Lot 38
Phase South
Model Eden (50-07) Elev C
LINA GARGARO

Colours Upgrade Report
The Castles of King City Print Date:27-Feb-17

- 1.WALK OUT BASEMENT (NO DECK NO STAIRS)
- 2.~~\$25,000~~ TO BE USED AT THE TIME OF DECOR APPOINTMENT ON UPGRADES FROM BUILDER STANDARD SAMPLES(INCLUSIVE OF HST)

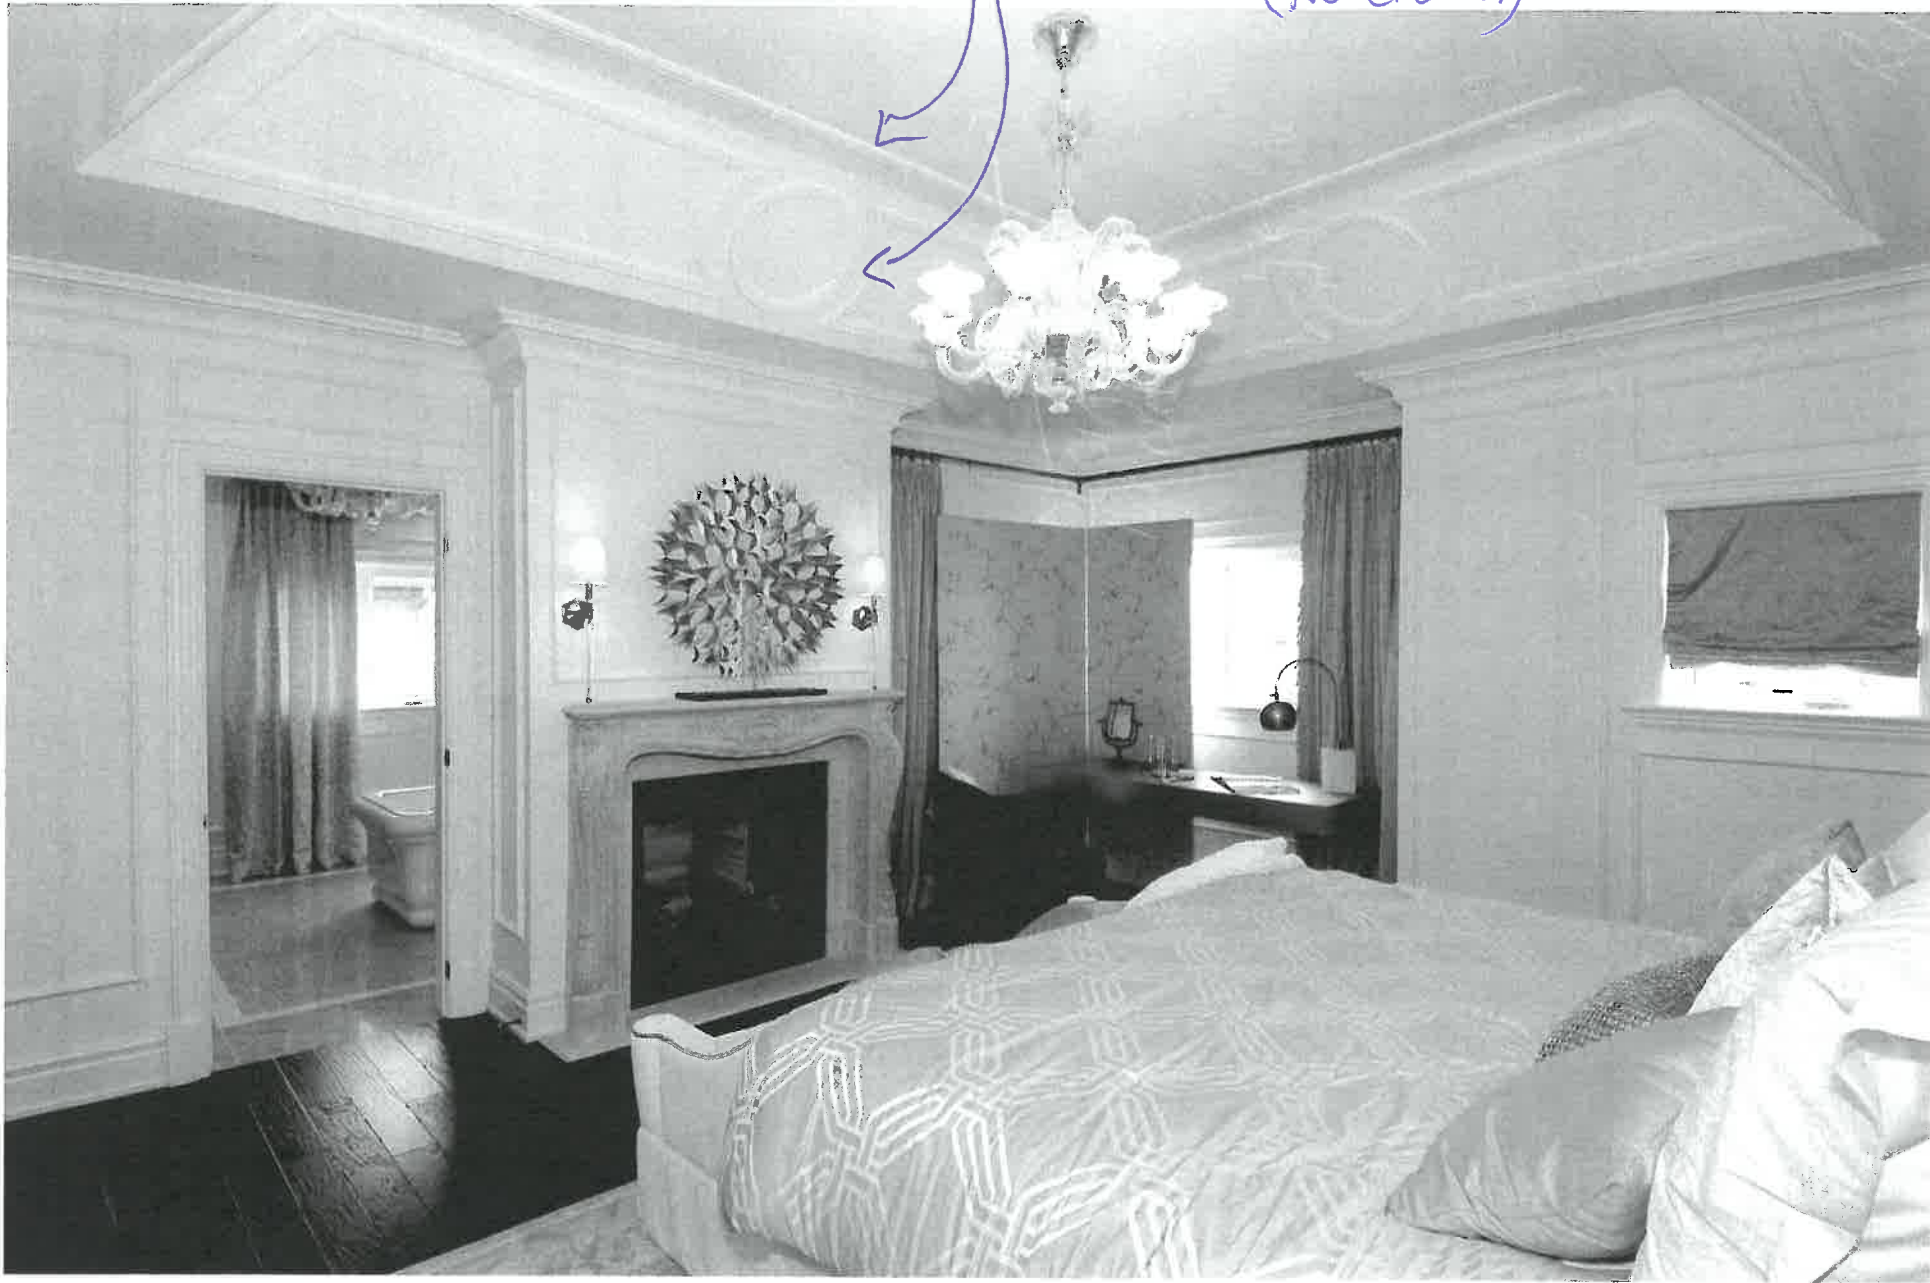
Top of box stops
2 inches from ceiling

Build out/up
to be flush
at front
with bottom
ledge.

DO NOT
Set back.

ledge to
go across
from wall
to wall

Reference for 38S Caotles

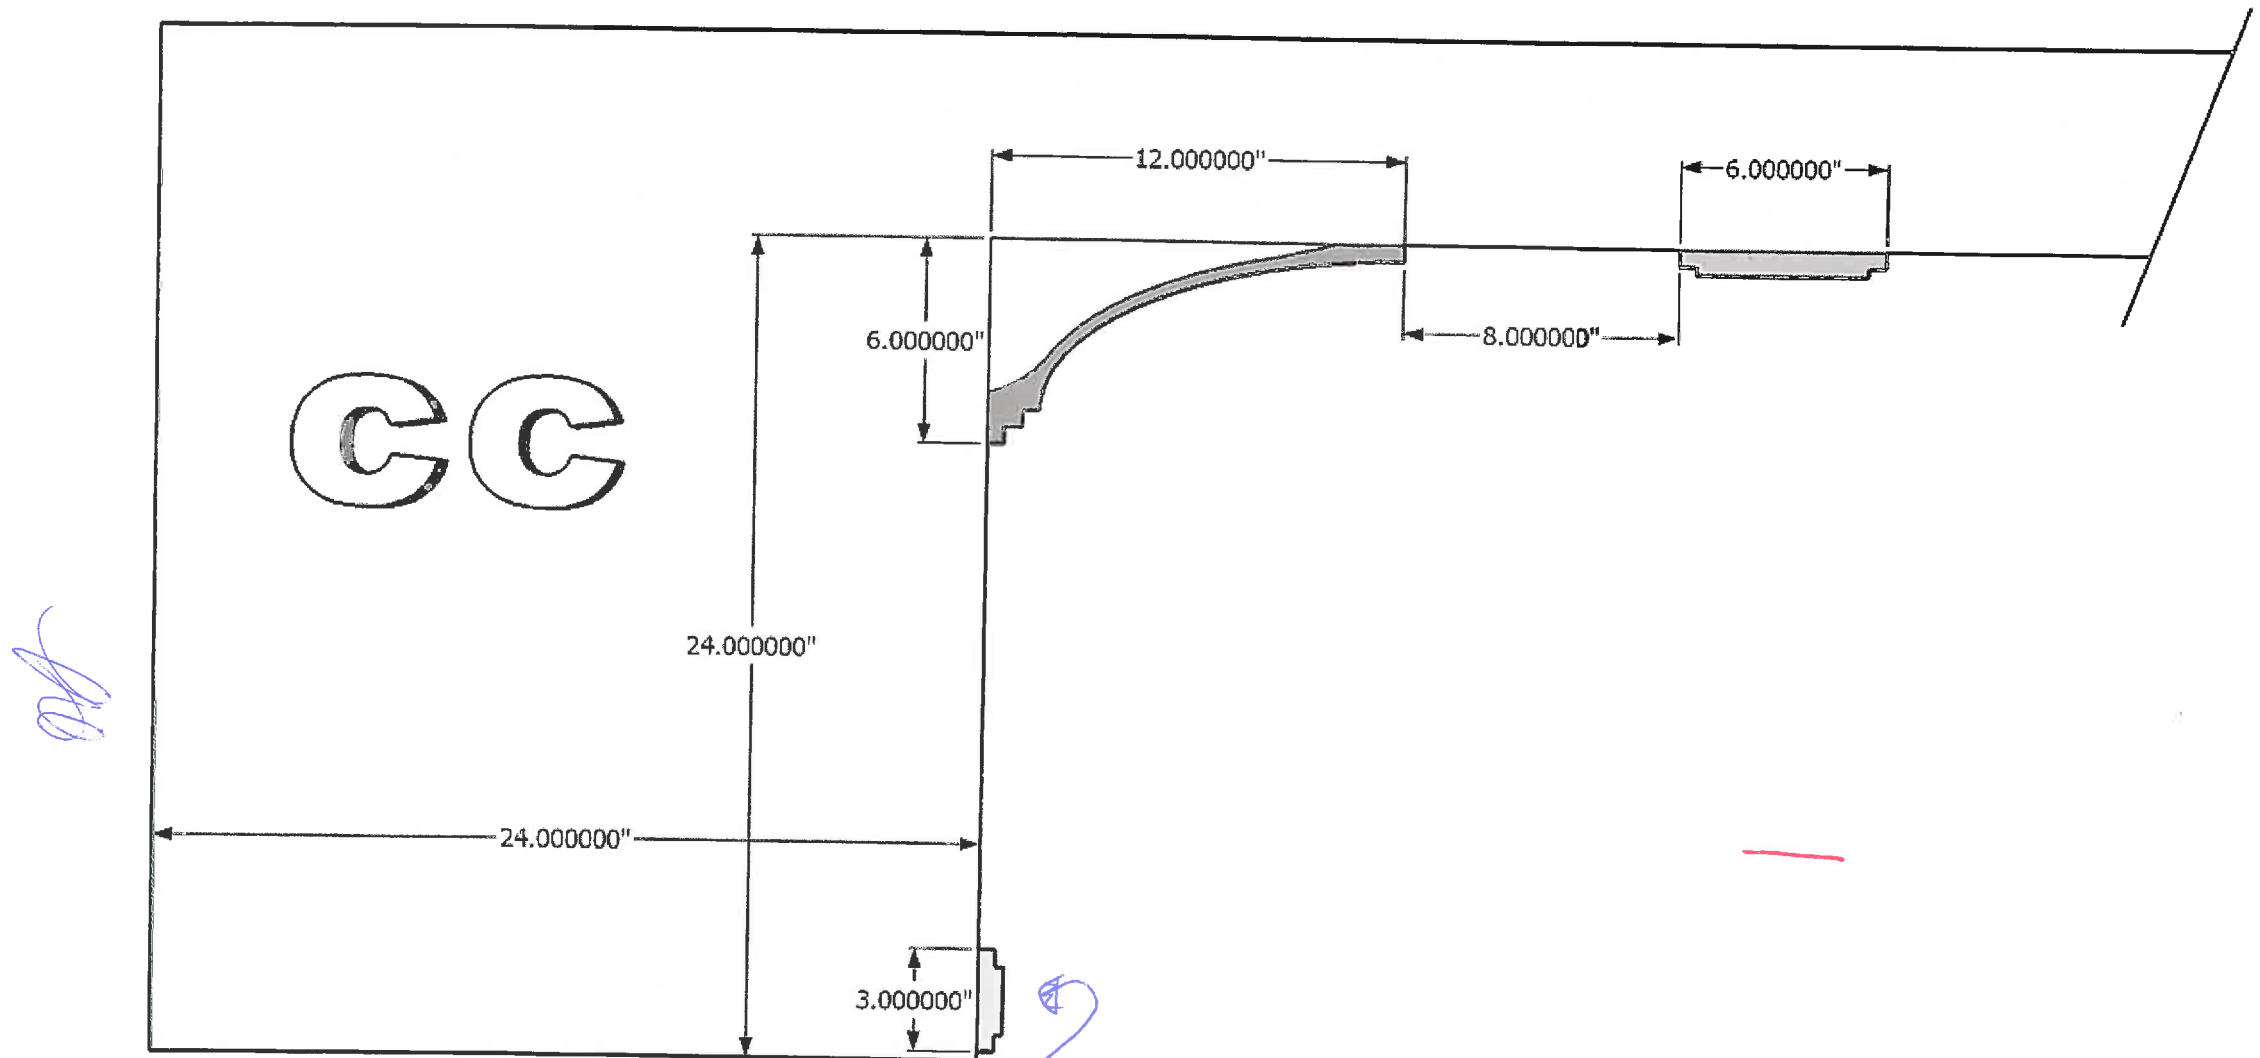
Band and tray detail only
(No Crown)

Reference for 38 S Castles

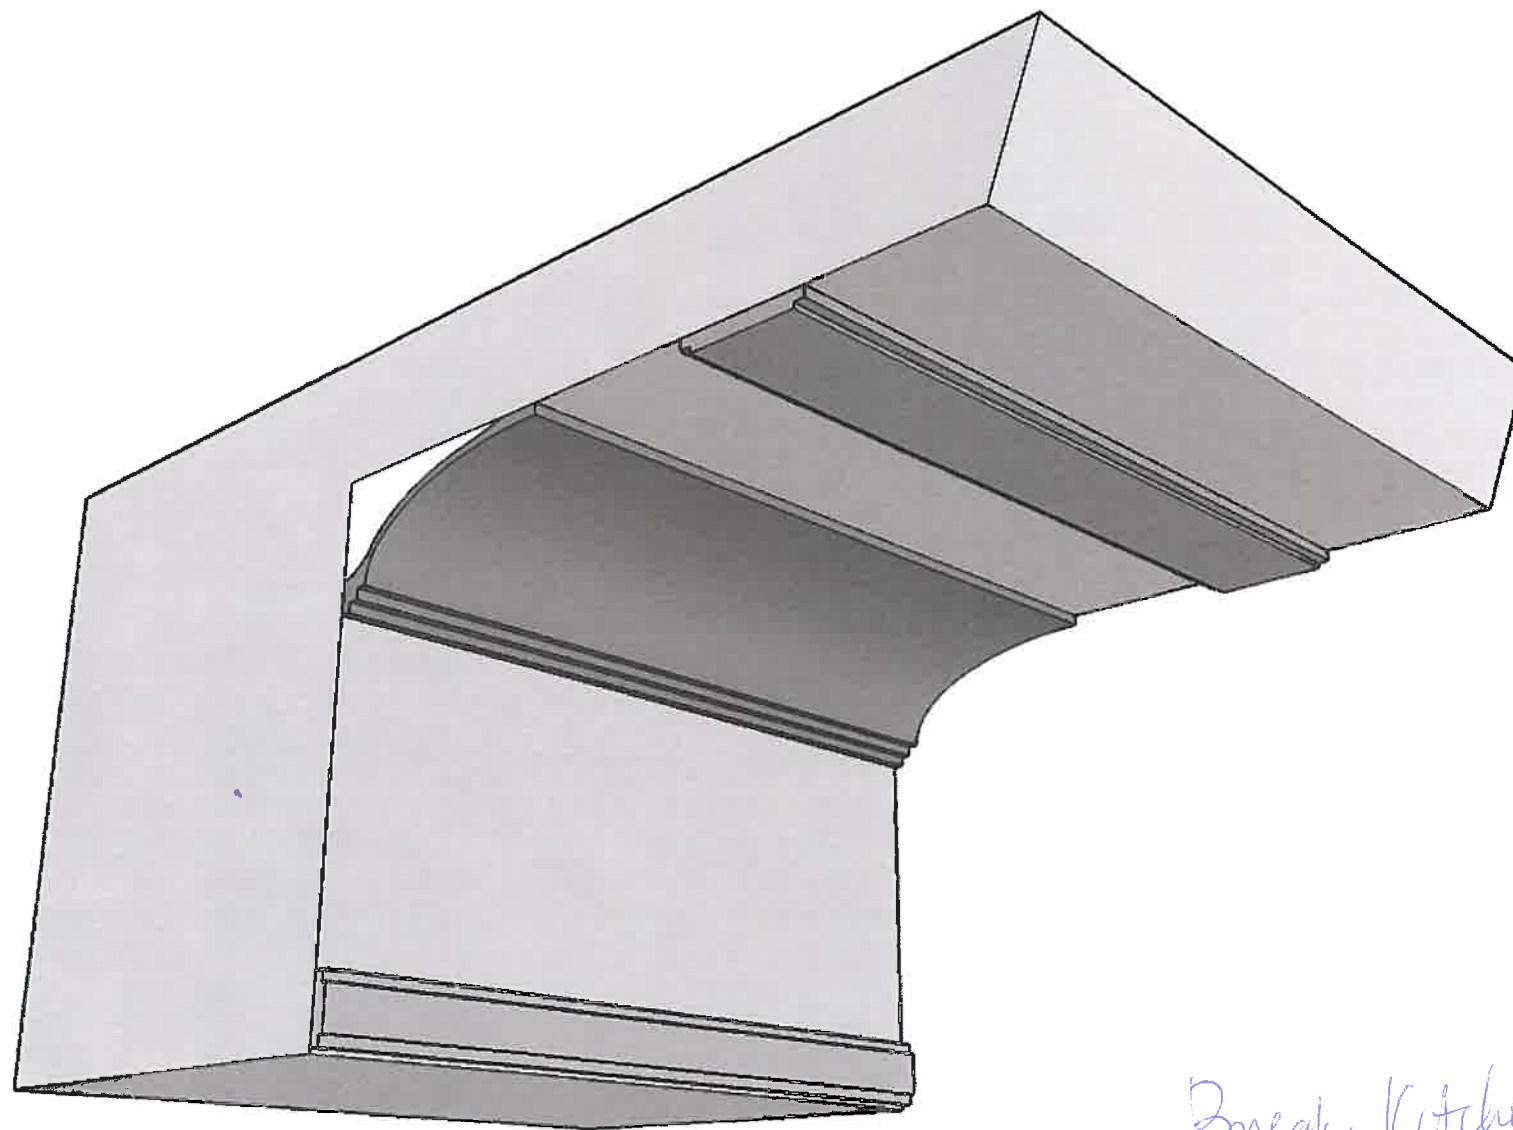
This style
or ceiling of
parlour
and master
Bedroom tray

SECOND FLOOR ELEV. 'C'
LOT 38S

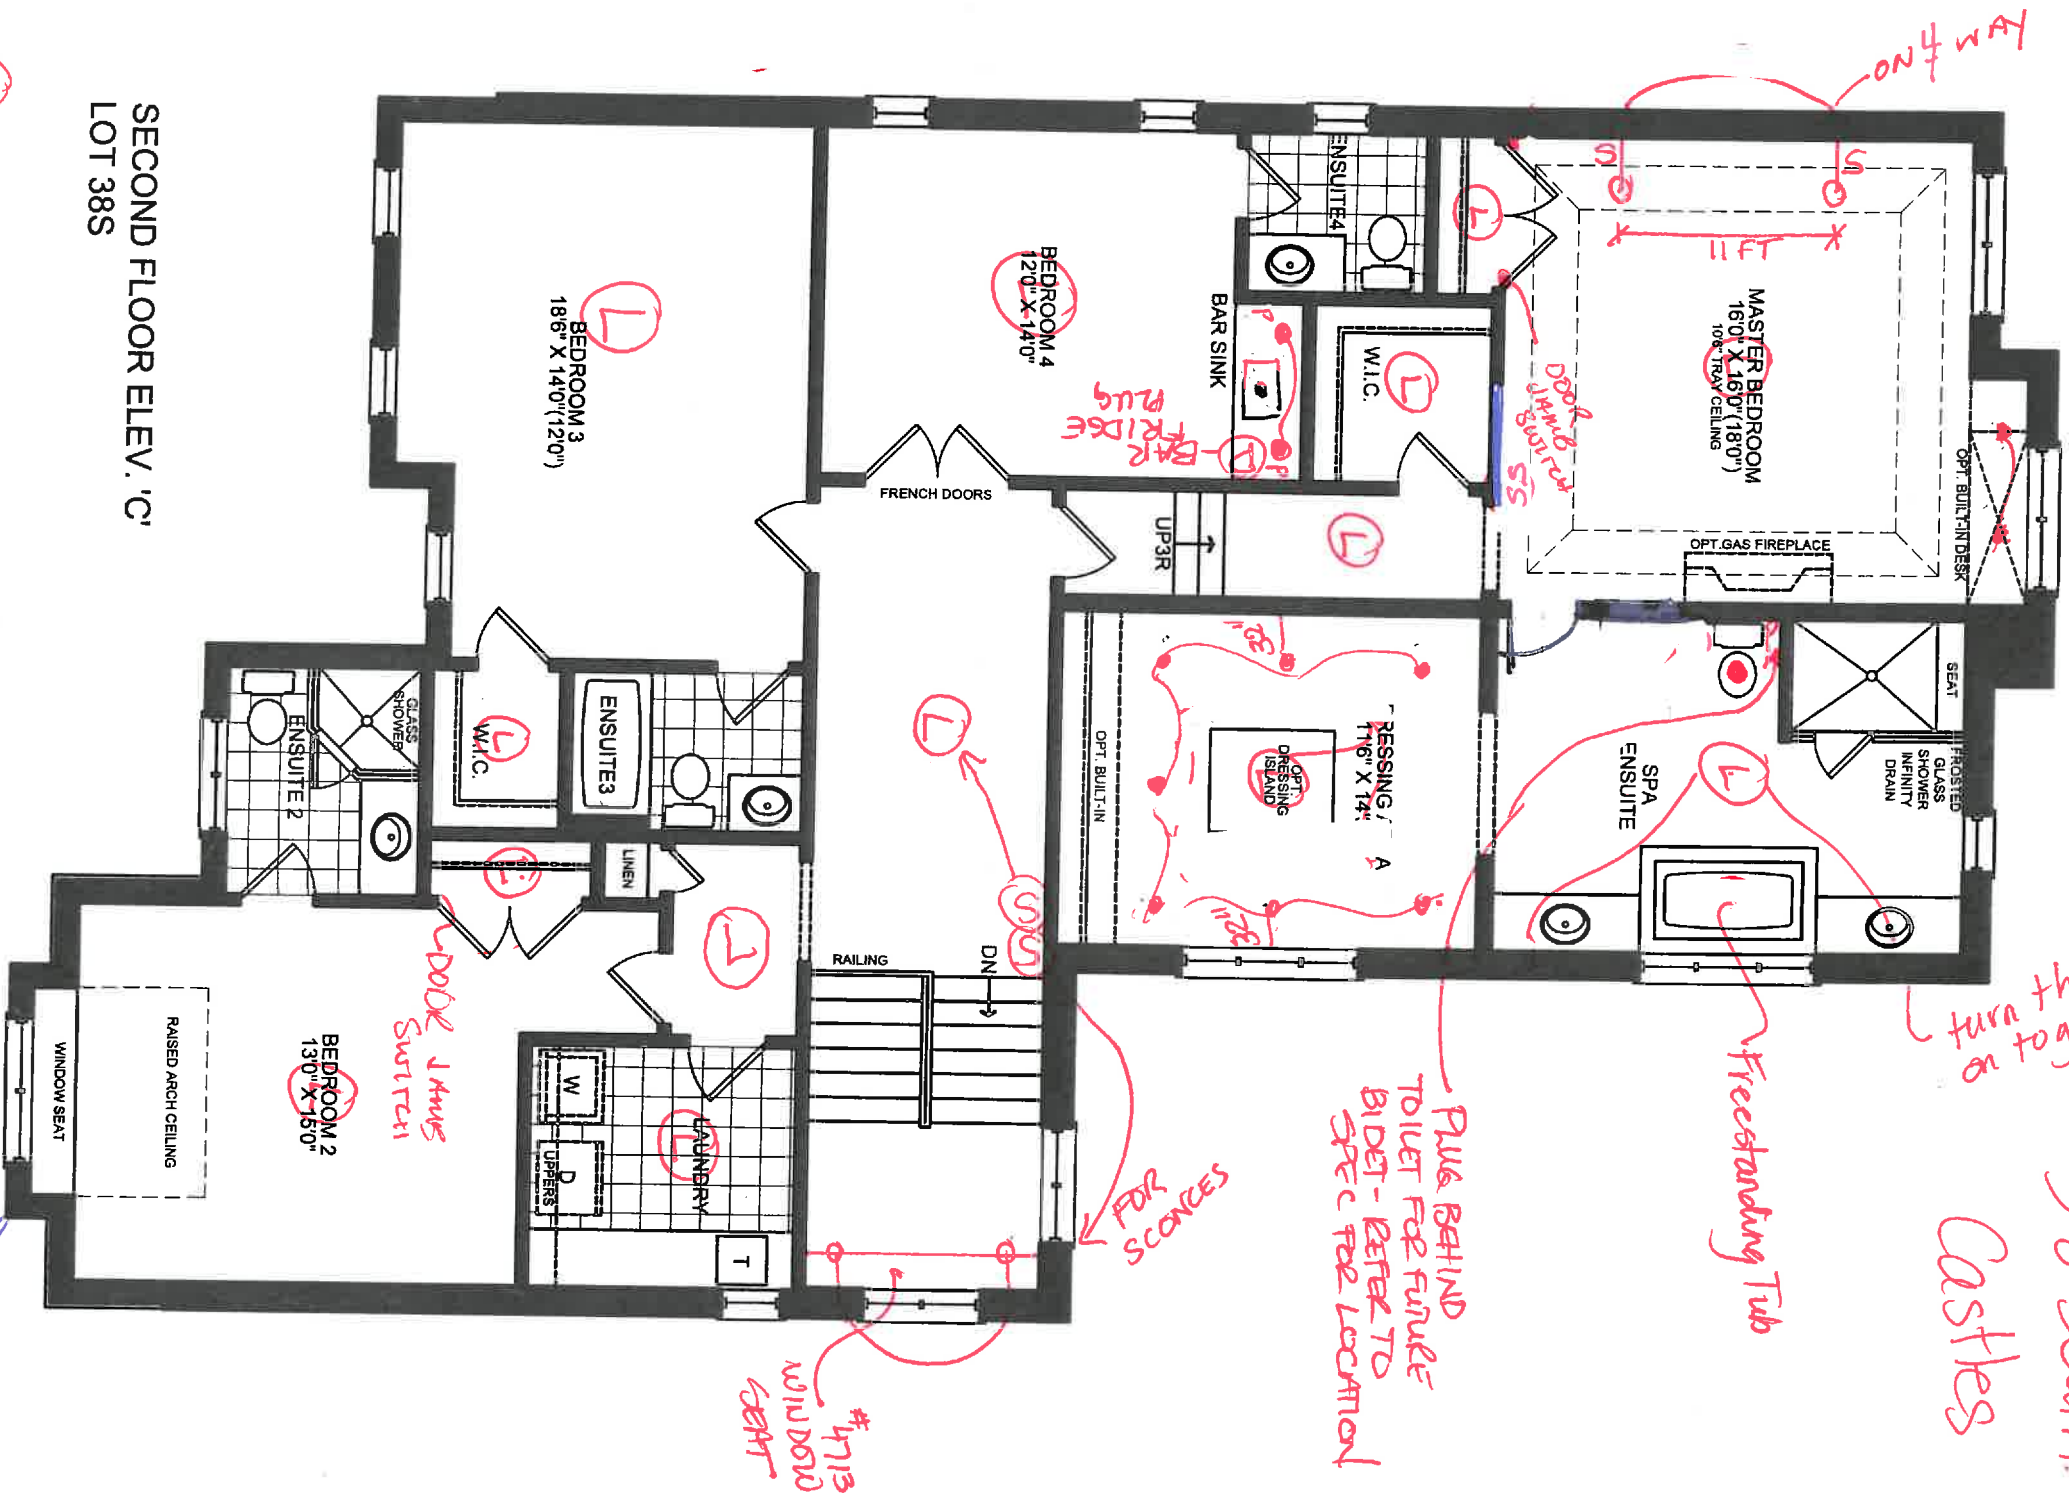
turn these
on together
